**Economic and Social Council**Distr.: General
3 March 2023

Economic Commission for Europe**Inland Transport Committee****World Forum for Harmonization of Vehicle Regulations****Working Party on Passive Safety****Seventy-third session**

UN Regulation No. 137 (Frontal impact with focus on restraint systems)**Proposal for the 03 Series of Amendments to UN Regulation No. 137 (Frontal impact with focus on restraint systems) *,******Submitted by the expert from the International Organization of Motor Vehicle Manufacturers**

Model A

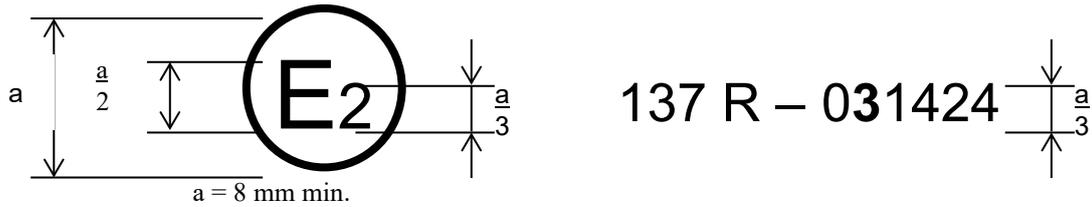
Annex 2, amend to read:

The above approval mark affixed to a vehicle shows that the vehicle type concerned has, with regard to the protection of the occupants in the event of a frontal collision, been approved in France (E 2) pursuant to Regulation No. 137 under approval number 011424. The approval number indicates that the approval was granted in accordance with the requirements of Regulation No. 137 03 series of amendments.

Model B

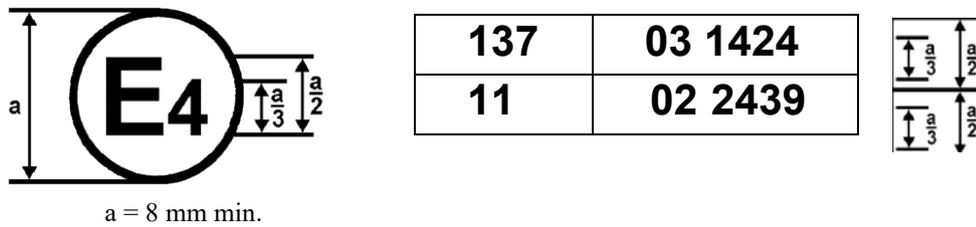
The above approval mark affixed to a vehicle shows that the vehicle type concerned has been approved in the Netherlands (E 4) pursuant to Regulations Nos. 137 and 11.¹ The first two digits of the approval numbers indicate that, at the dates when the respective approvals were granted, Regulation No. 137 incorporated the 03 series of amendments and Regulation No. 11 incorporated the 02 series of amendments.
